No.6 Sleigh Place, Wetherill Park

Acoustic Assessment for 24hr Operation

Author	Fu Siong Hie, B.Eng, MAAS Principal Consultant
Document Reference:	SYD2014-1079-R005E
Date	28/10/2024
Comments:	Response to Council & EPA (Refer to Section 1.1 for summary) R2 change to residential receiver. Sleep disturbance (Section 3.2) Appendix B & C

1.1 Summary of Response to Council

Figure 3 –Day/Evening/Night Time Operation Noise Model ($L_{eq((15min))}$ dBA)

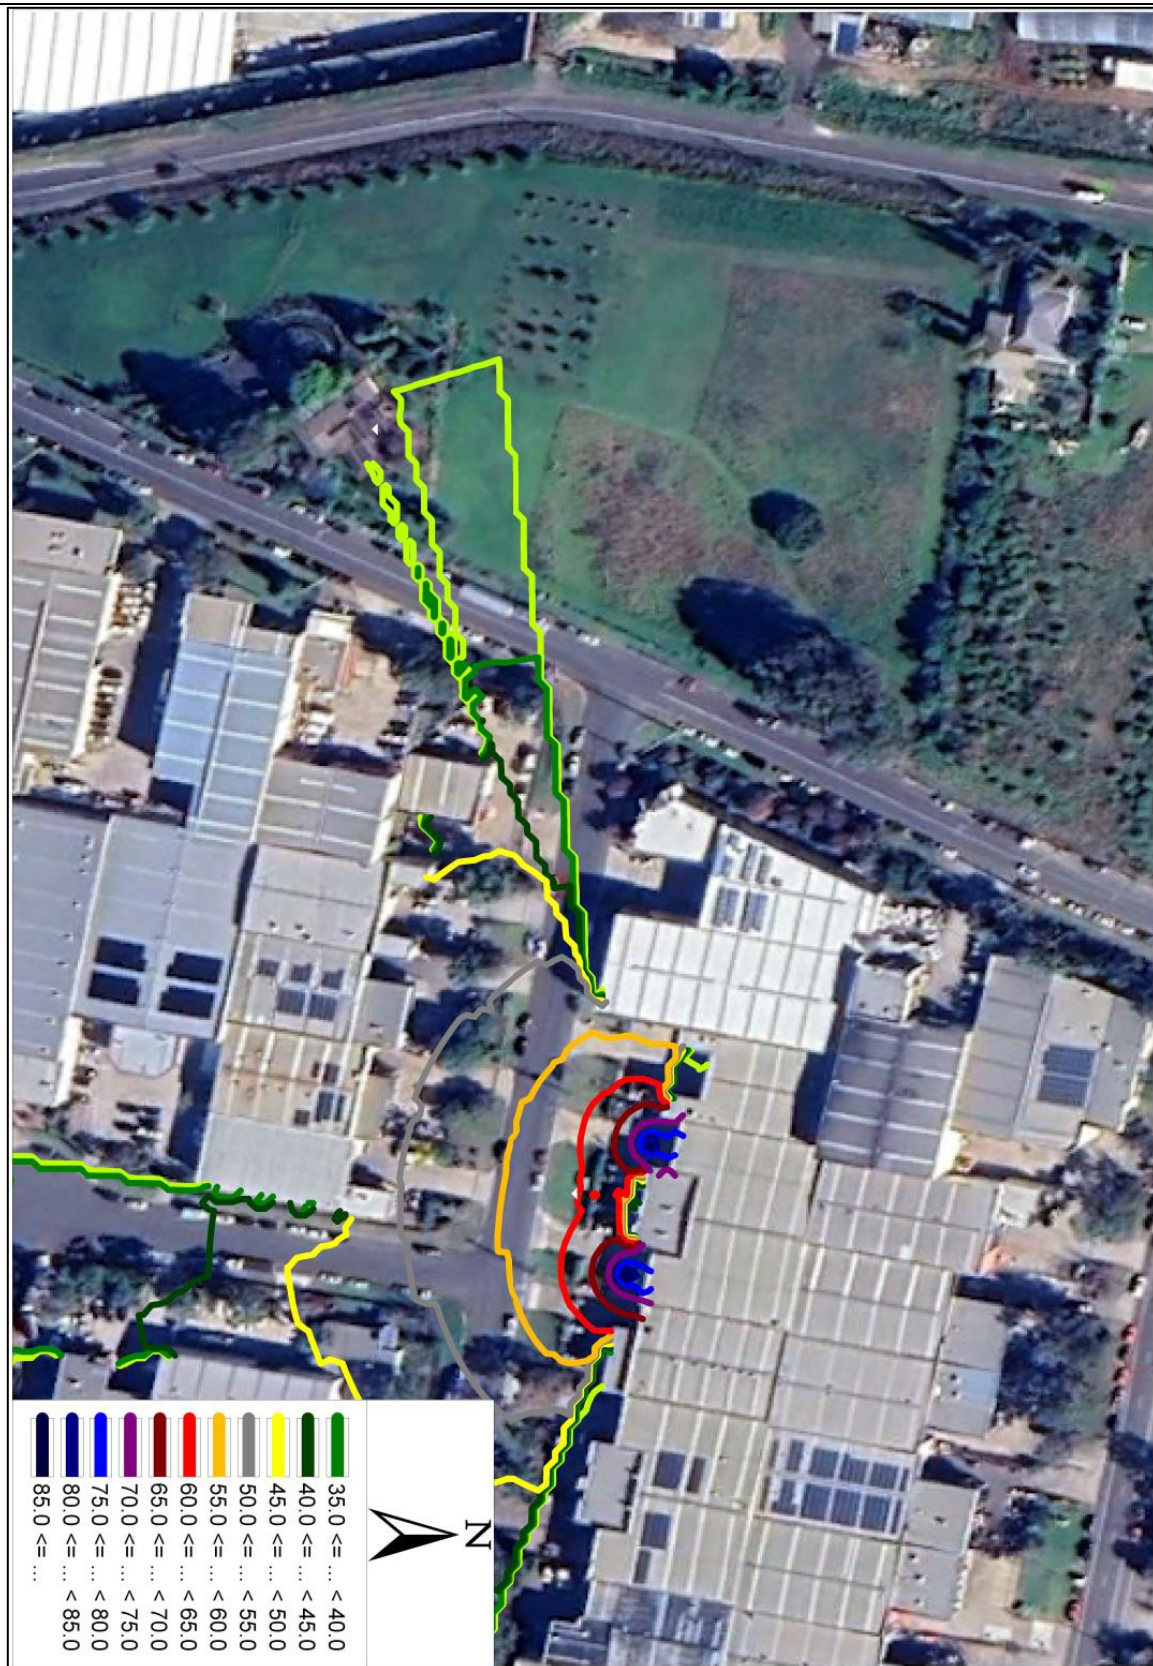
The Odour Assessment has been reviewed and the EPA requests that the proponent provide additional information to confirm predicted odour impacts and demonstrate the adequacy of the proposed odour mitigation measures. This includes:

- Provision of odour sampling analysis reports;
- Details of any proposed scrubbing prior to discharge;
- Clarify if the rotary drum is enclosed or fitted with ventilation extraction;
- Demonstrating the ventilation system is adequately sized to capture odour from all odour emission sources;
- Clarification is required on the assessment of impacts at the nearest sensitive receptors. The noise impact assessment indicates the presence of residential receivers approximately 250 m to the west. However, the odour assessment states that the nearest residential community as being approximately 1.5 km to the south; and
- Any implications on the odour assessment, noting the comments provided.

2(b): Refer to Figure 3 and Figure 4.
